ADDENDUM NO. 1

DATE OF ISSUANCE: April 12, 2024

PROJECT: 2024 Addition and Renovations
North Harrison Elementary School
1115 W. Whiskey Run Road
Ramsey, IN 47166

ARCHITECT'S PROJECT NO.: 23-228.001

ROOF PLAN
1/8" = 1'-0"

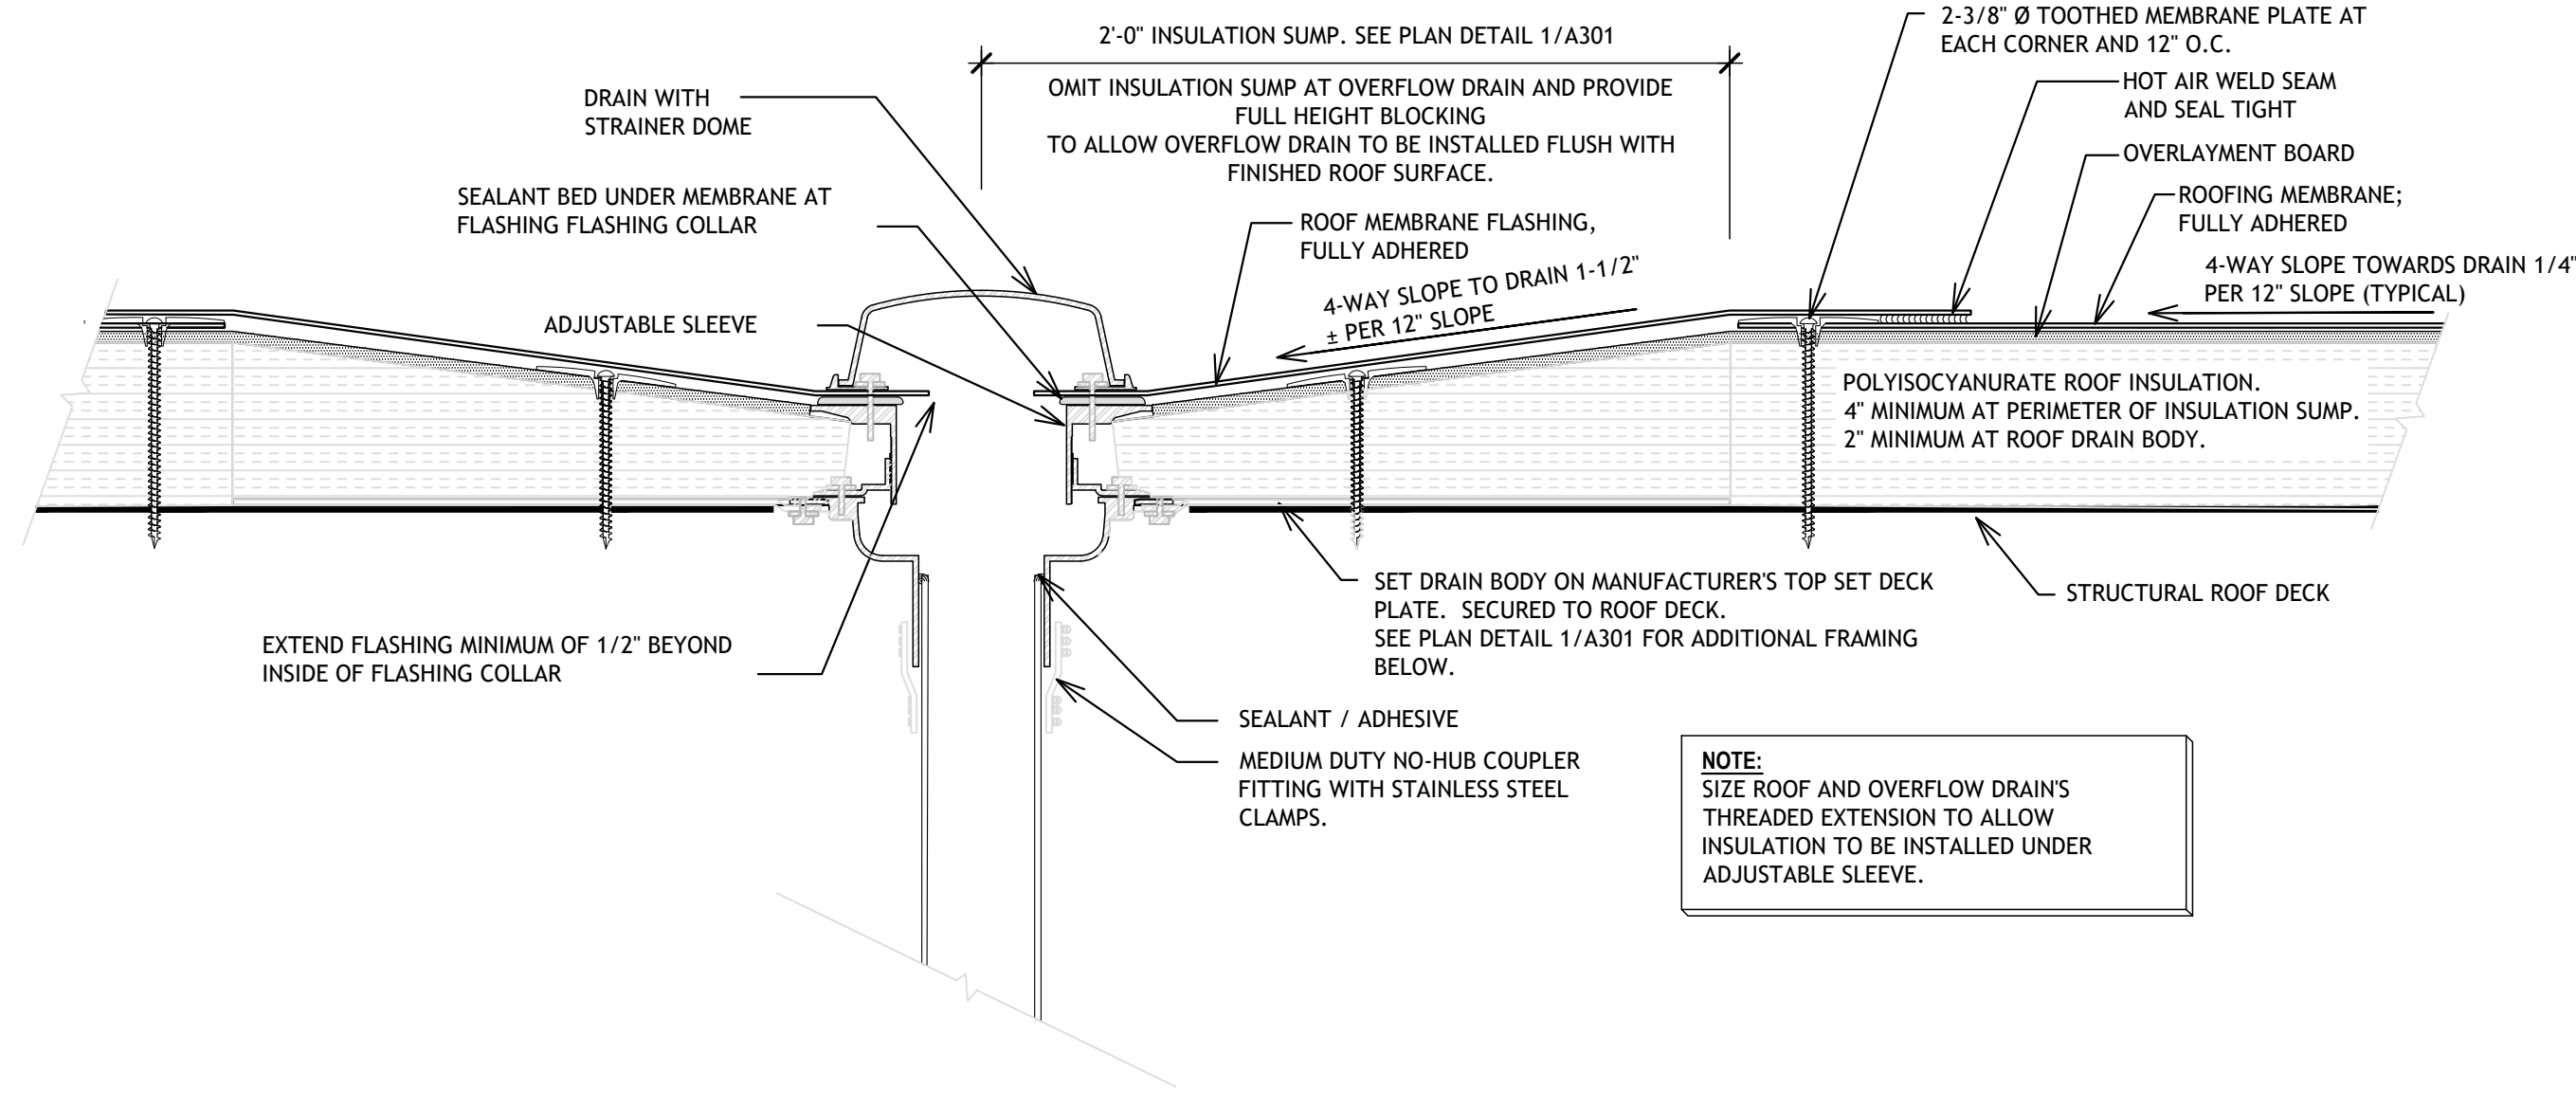
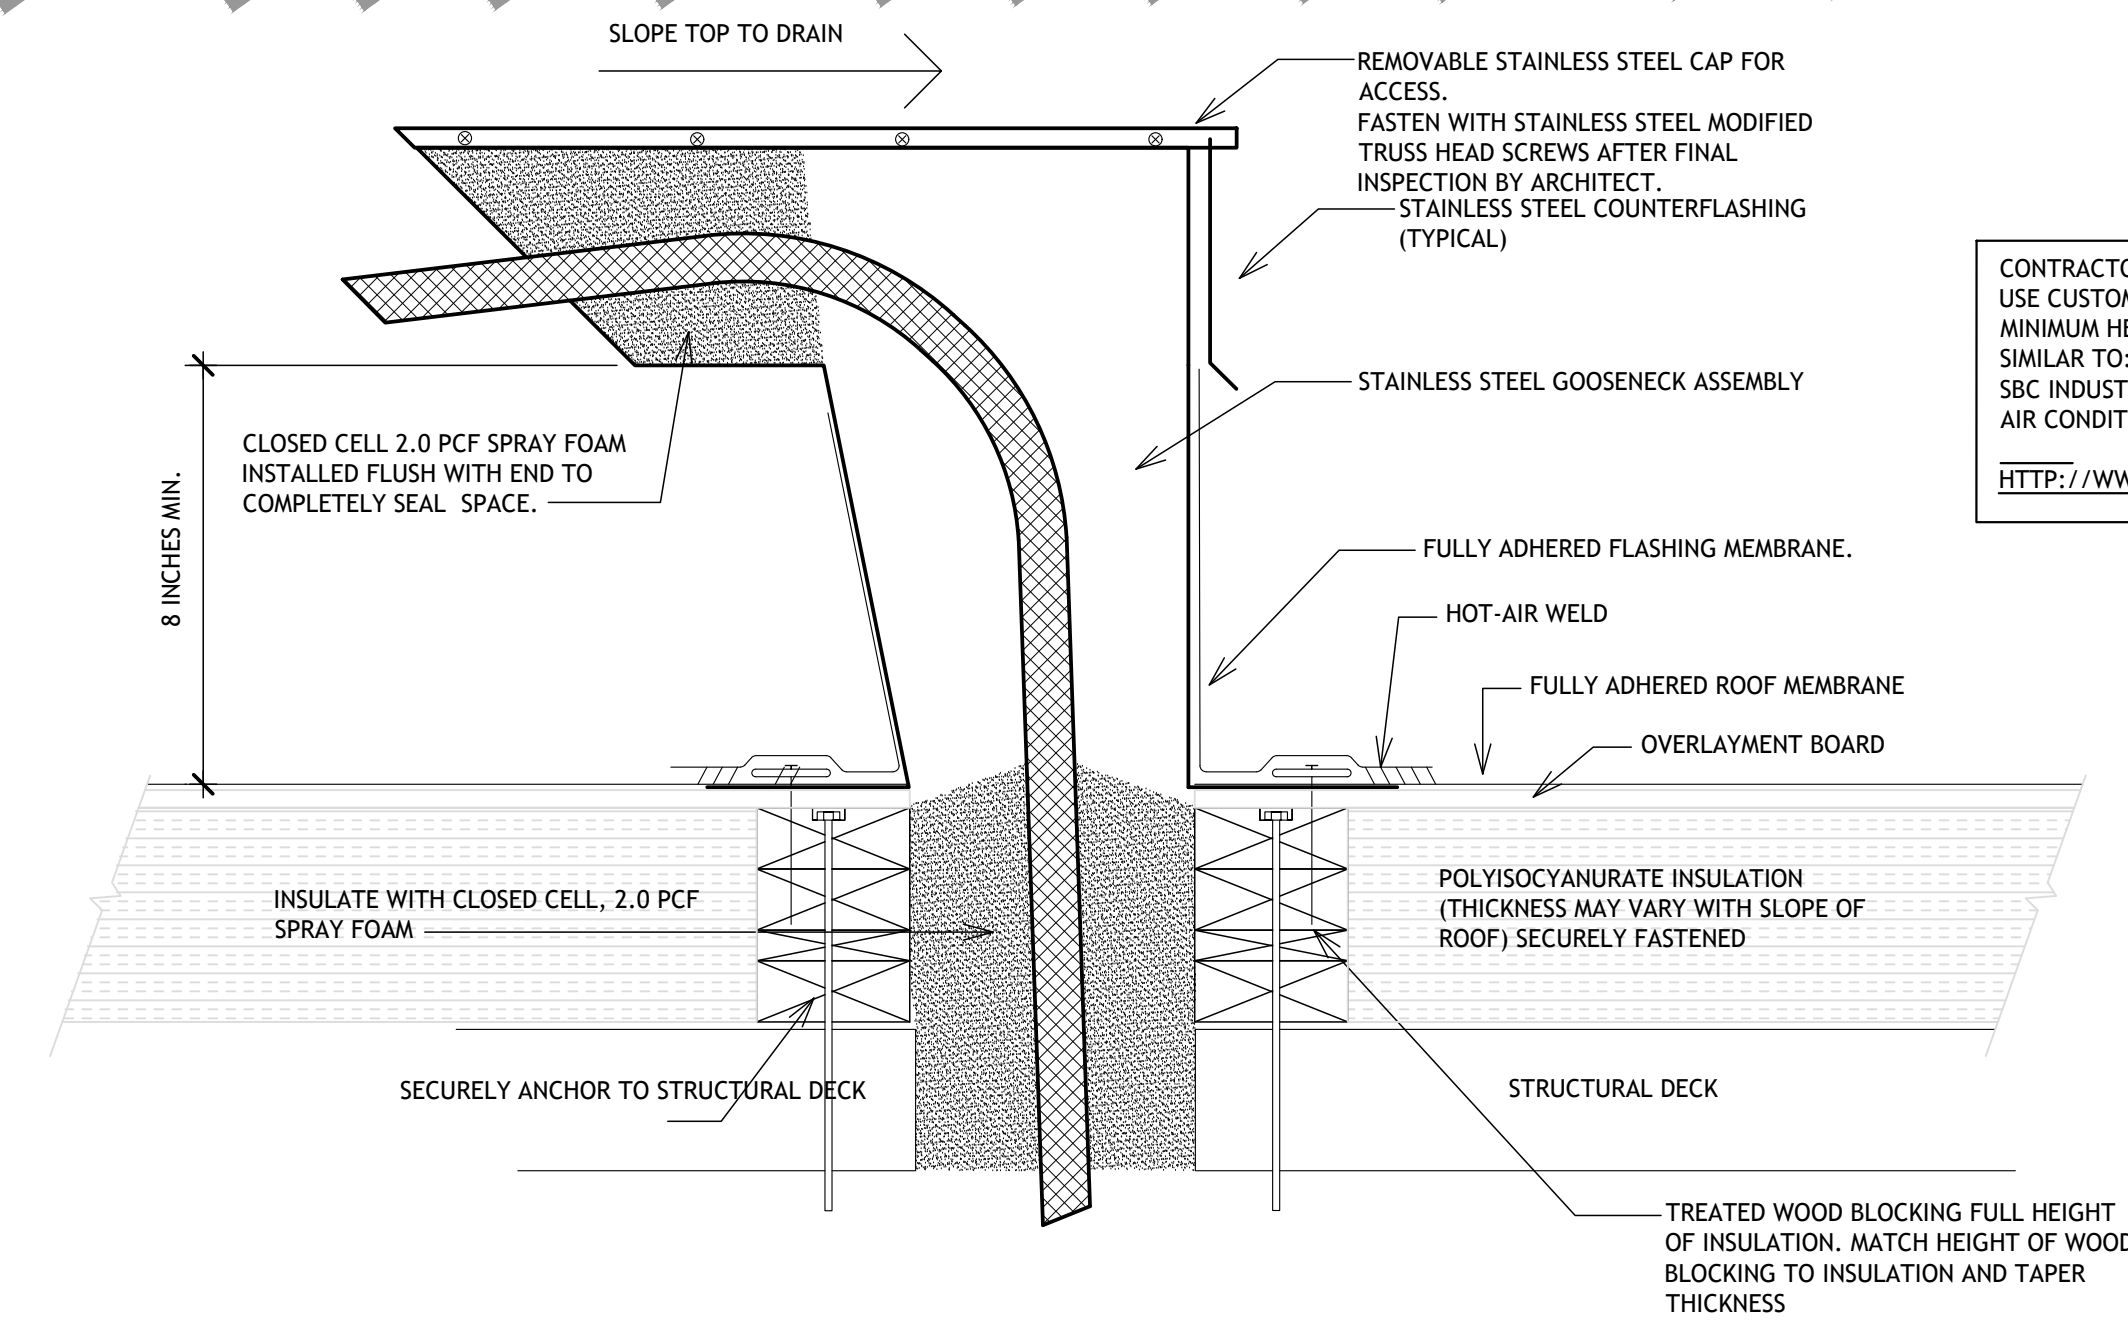
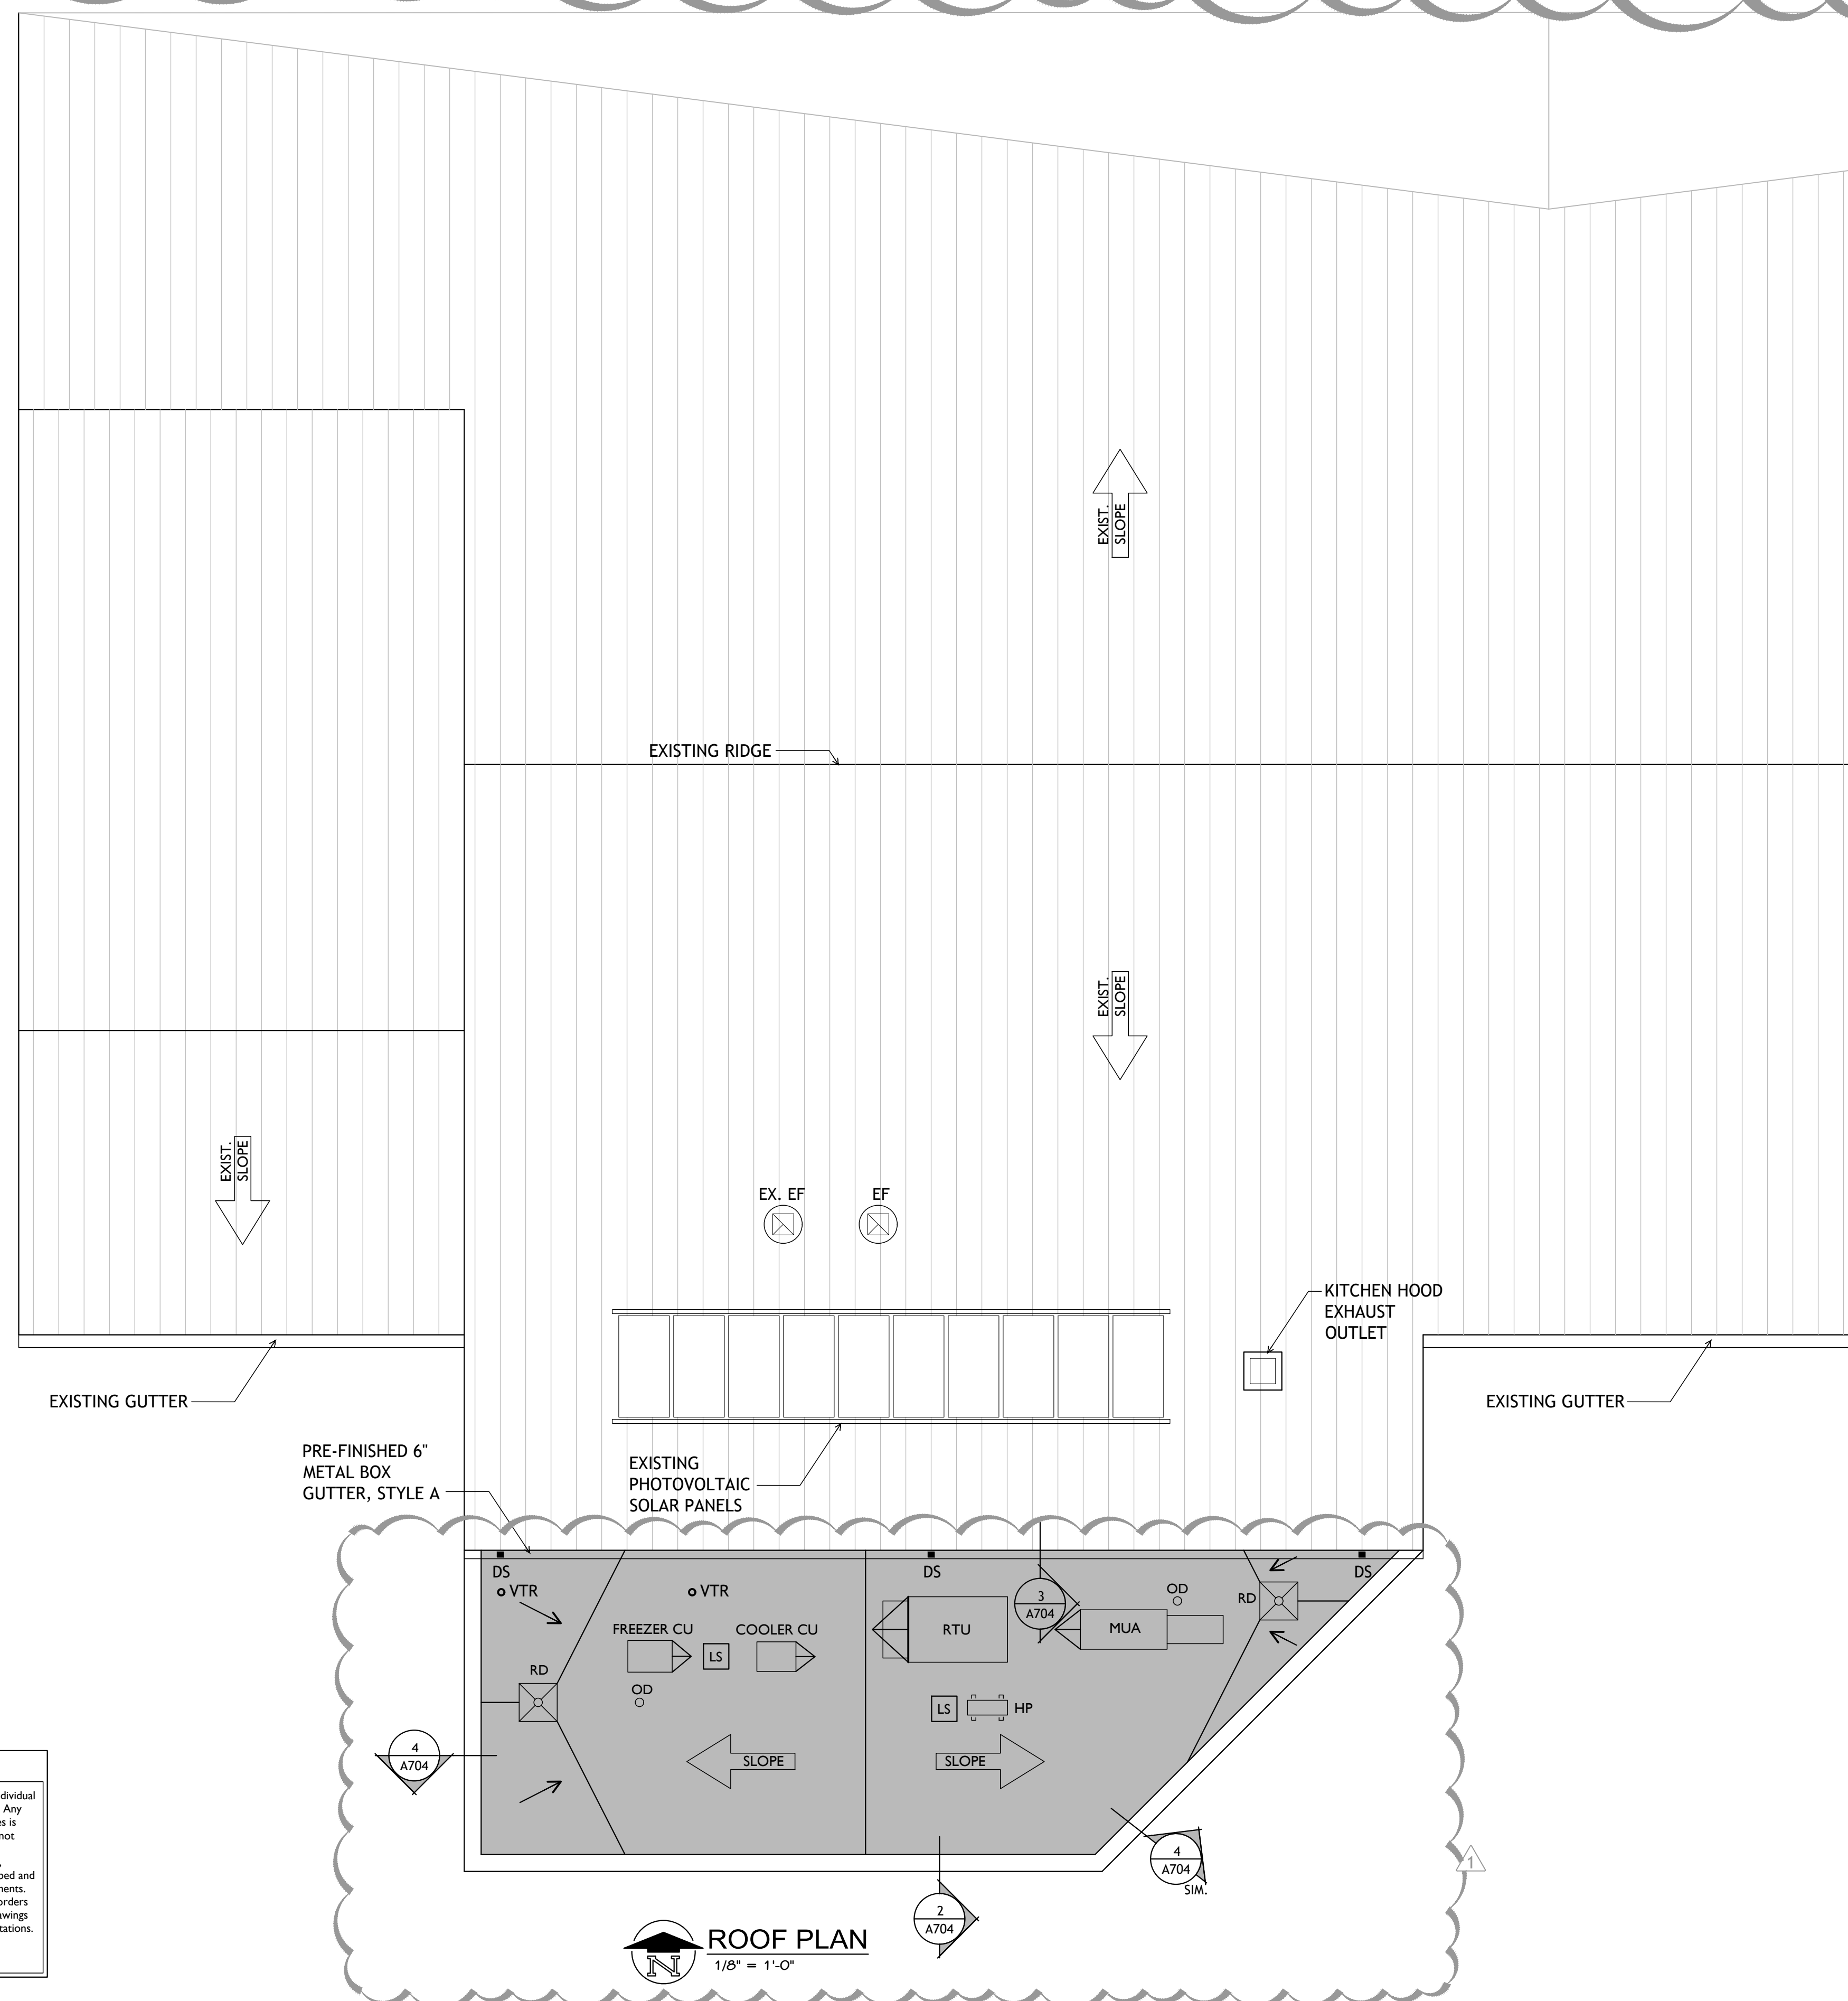
CHANGES TO DRAWINGS**ADD-1 Item No. D-1 - Roof Plan**

Refer to Sheet(s): **A301**

Replace with attached revised Drawing in its entirety; revisions have been clouded for reference.
